PROJECT ID NO. SWQ0000005

**MONTEITH PARK AND VIEW PARK
GREEN ALLEY STORMWATER IMPROVEMENTS**

NOTICE INVITING BIDS

SECTION E2-E2

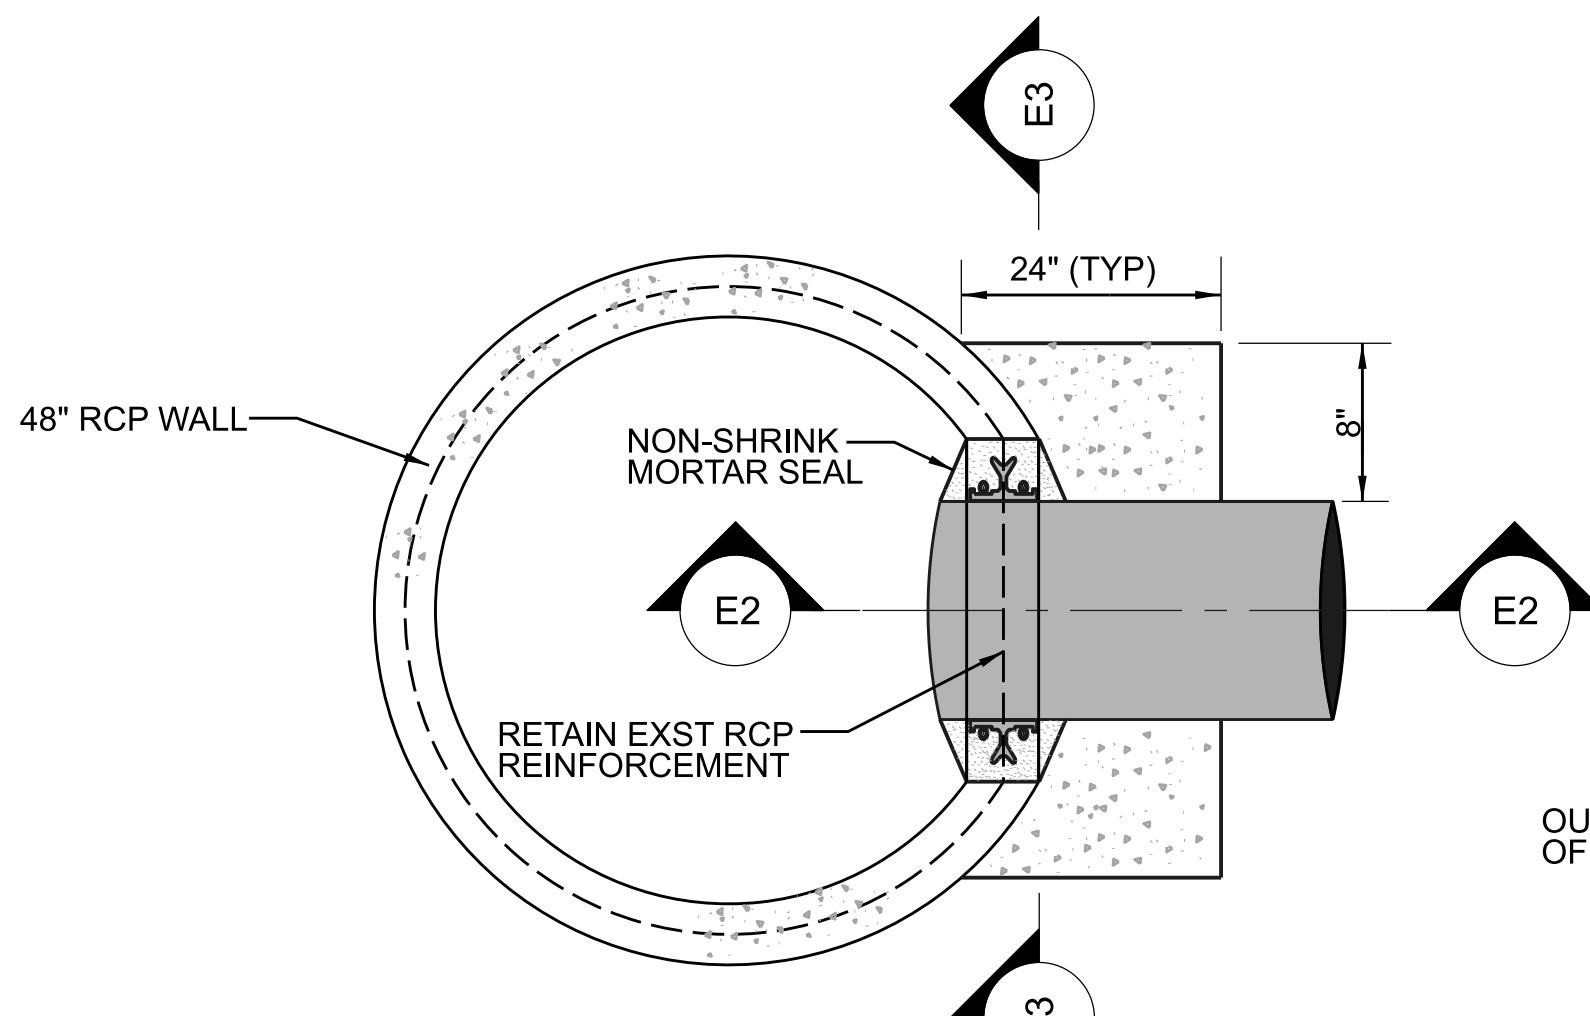
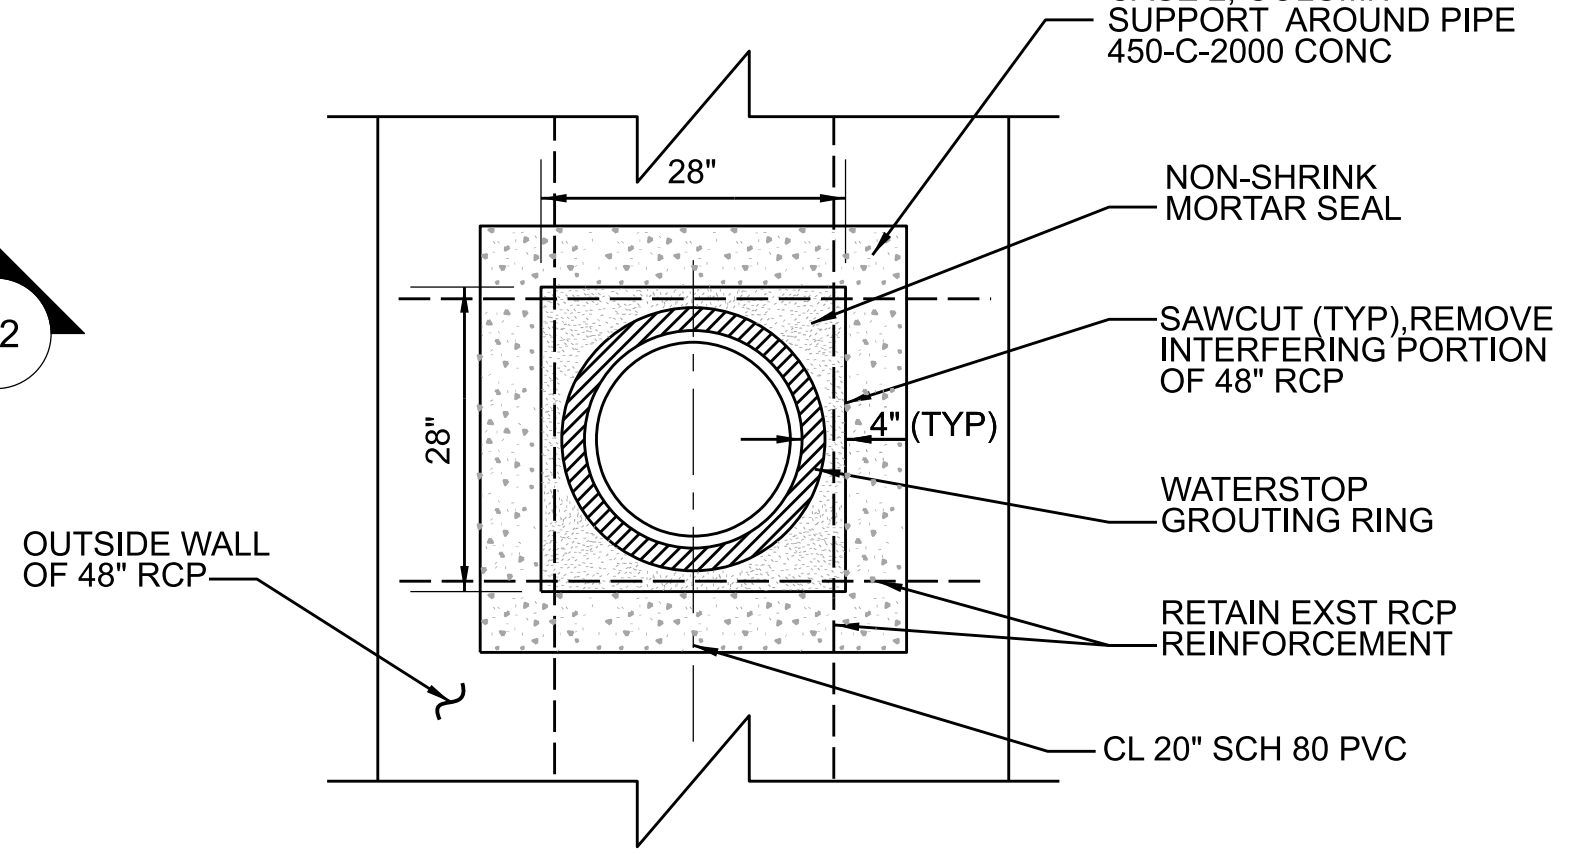
- *Sheet DR-8 (sheet 8 of 70) – Revision 4 – added right-of-way dimensions*
- *Sheet DR-9 (sheet 9 of 70) – Revision 3 – added right-of-way lines and dimensions*
- *Sheet DR-10 (sheet 10 of 70) – Revision 2 – changed depth from 78' to 68', changed label*
- *Sheet DR-14 (sheet 14 of 70) – Revision 1 – changed inflow and outflow pipe from 24" RCP to 20" PVC*
